From: Barna, Roberta (EXT)
Sent: 30 September 2025 11:05
To: Jane Curley
Cc: Planning (SMDC)
Subject: DOC/2025/0040 - Fole Dairy - LLFA Response (Rev 1)

Staffordshire County Council Flood Risk Management Position

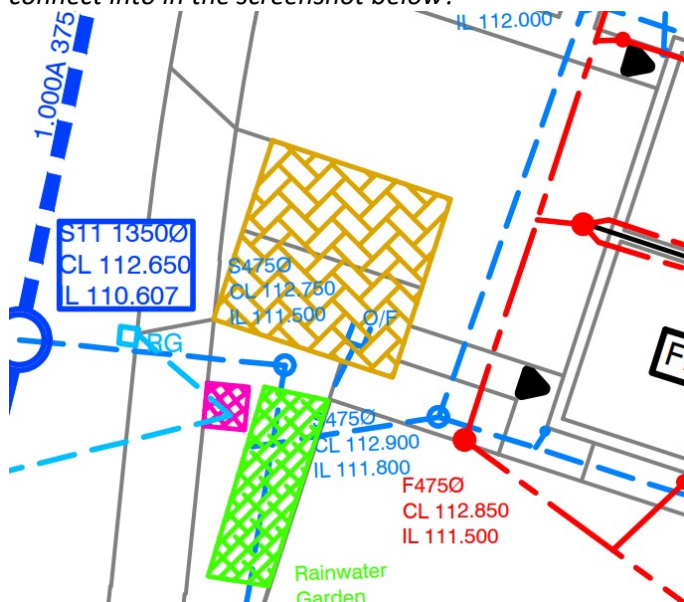
- *Please provide detailed design for all tanks (including top water levels in the 100yr+CC water levels).*
- *Please ensure all pipes connect somewhere as this makes review a lot easier e.g. where does this PP outfall connect into in the screenshot below?*
